PROPOSED CHANGE RTS-115 TO DAEC TECHNICAL SPECIFICATIONS

DUANE ARNOLD ENERGY CENTER

DOCKET NO. 50-331

Figure B-1. Gaseous Radioactive Waste Flow Diagram

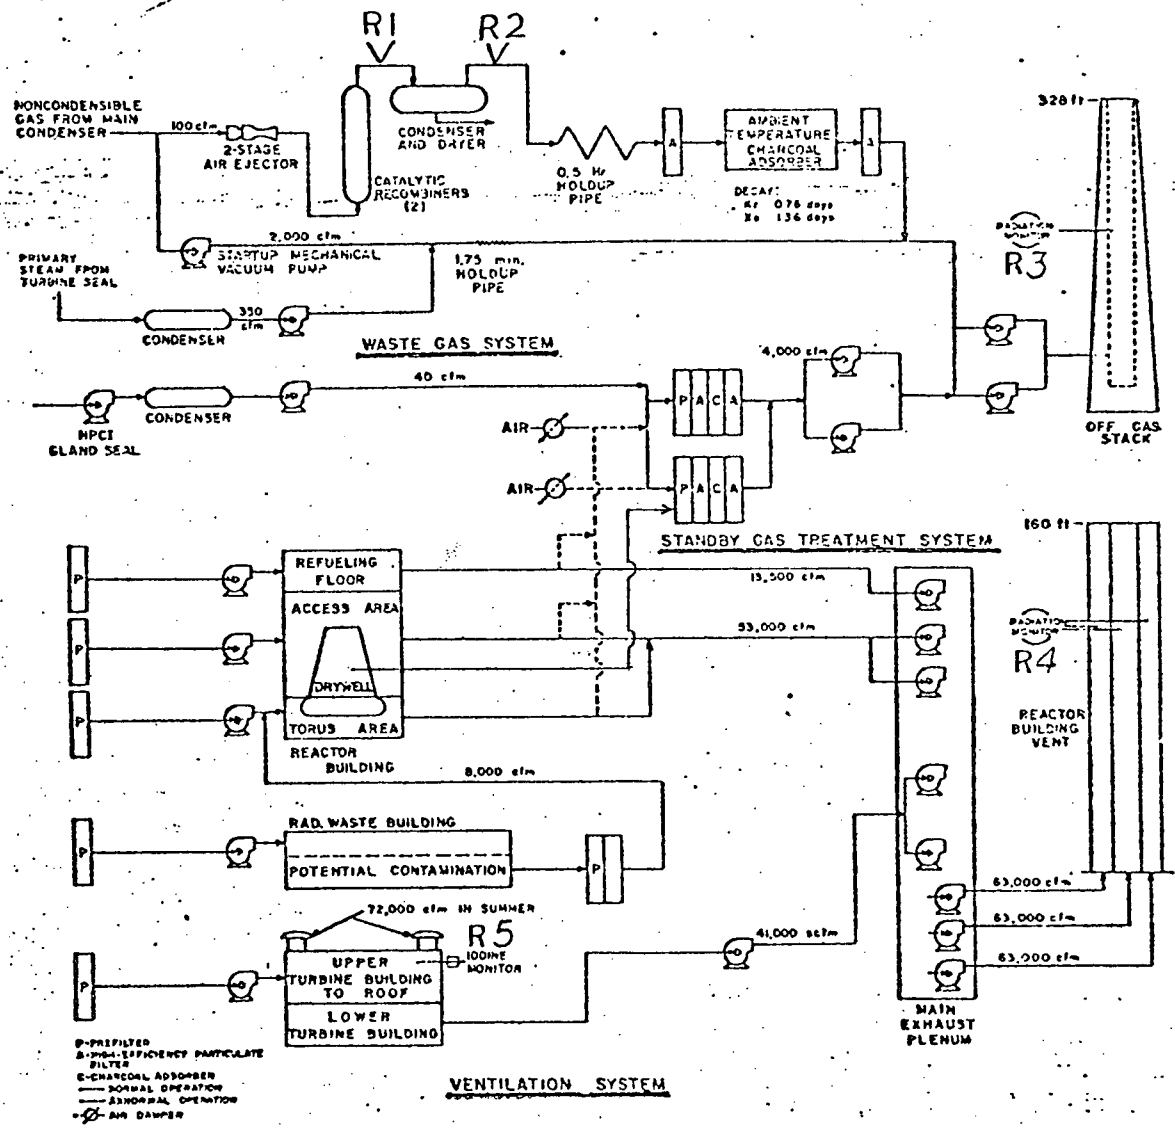
4.15.6 The concentration of hydrogen in the main condenser offgas treatment system shall be determined by continuously monitoring the waste gases in the main condenser offgas treatment system with the hydrogen monitors (ref. Figure B-1 at point R2) required OPERABLE by Table 3.15-1 of Specification 3.15.1.

both radioactive and explosive gaseous effluents is depicted in Figure B-1. The OPERABILITY and use of these instruments implements the requirements of 10 CFR Part 50, Appendix A, General Design Criteria 60, 63, and 64.

Figure B-1 is a flow diagram depicting gaseous radioactive waste streams. The Standby Gas Treatment System is considered an Engineered Safety Feature and not a Ventilation Exhaust Treatment System.

FIGURE 4.1-1 NON-RADIOLOGICAL CEDAR RIVER OPERATIONAL SAMPLING LOCATIONS

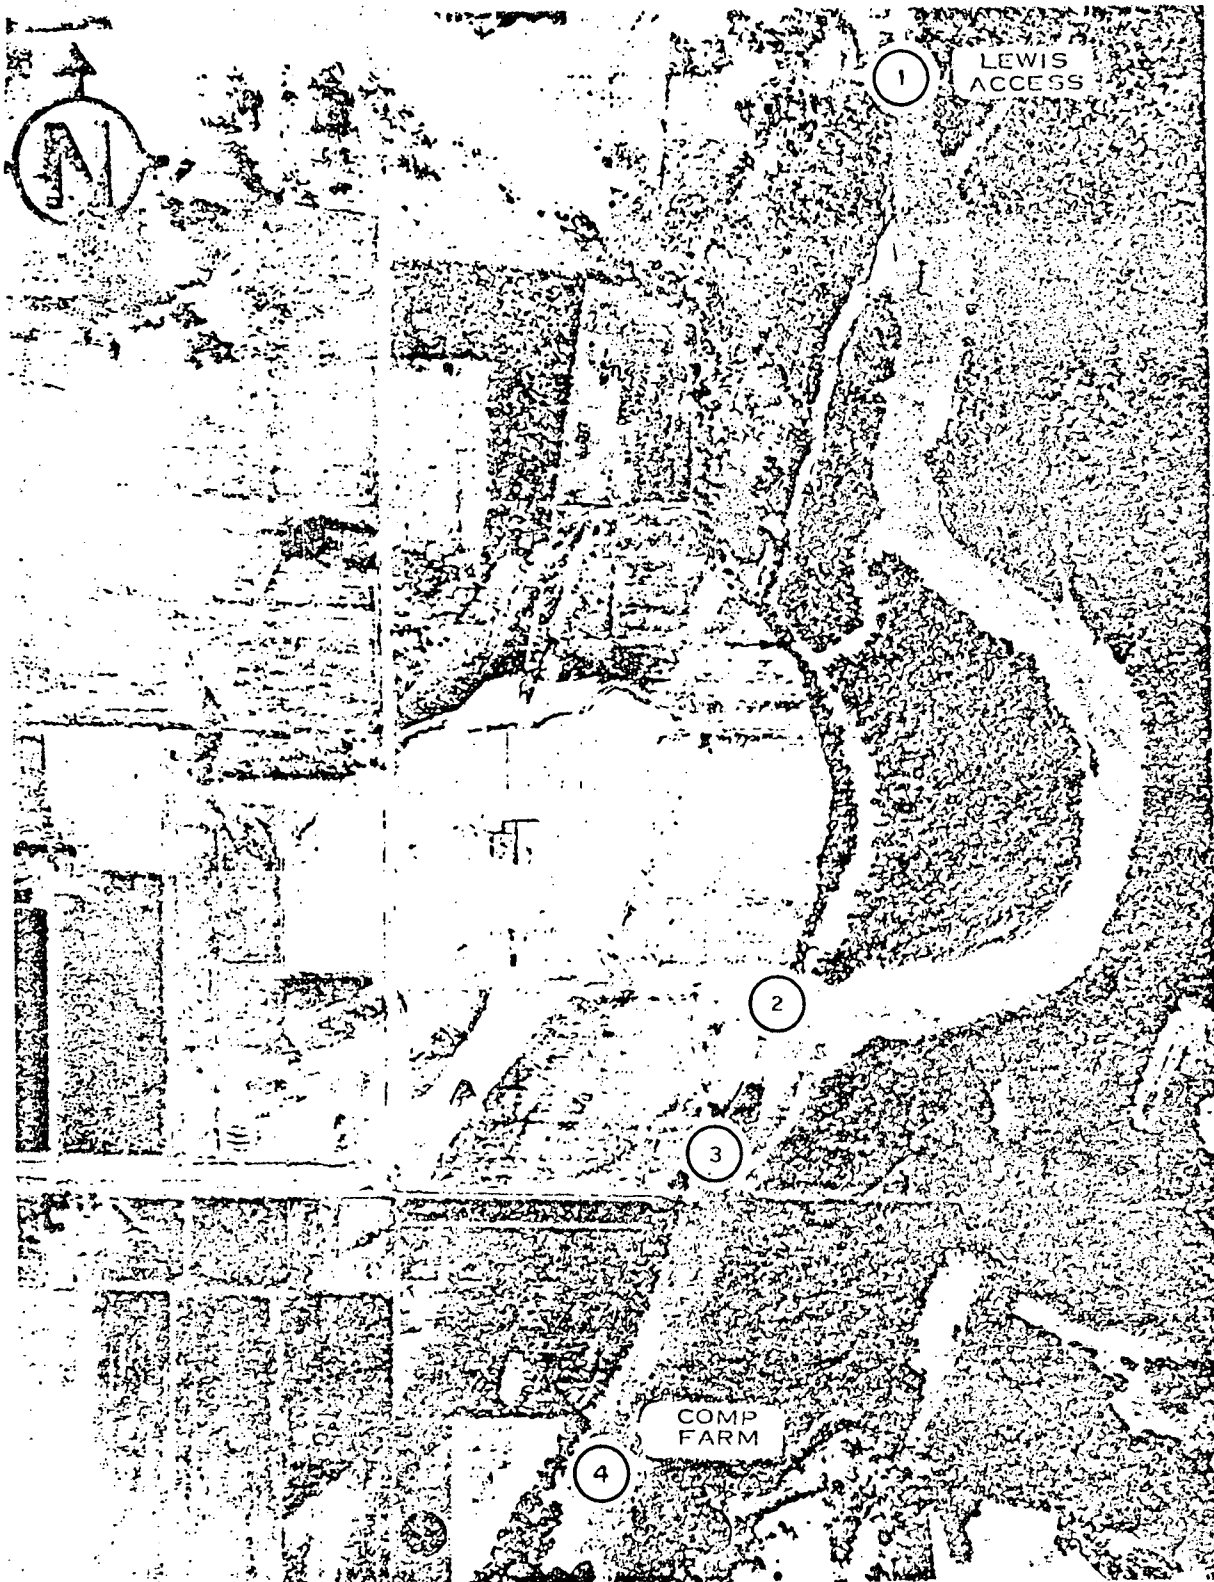
Revise the Table of Contents as indicated on the attached sheets. Delete Specifications 2.3, 3.3, 4.3 and 5.0 and change the number of Page "4.3-12" to "4.1-7."
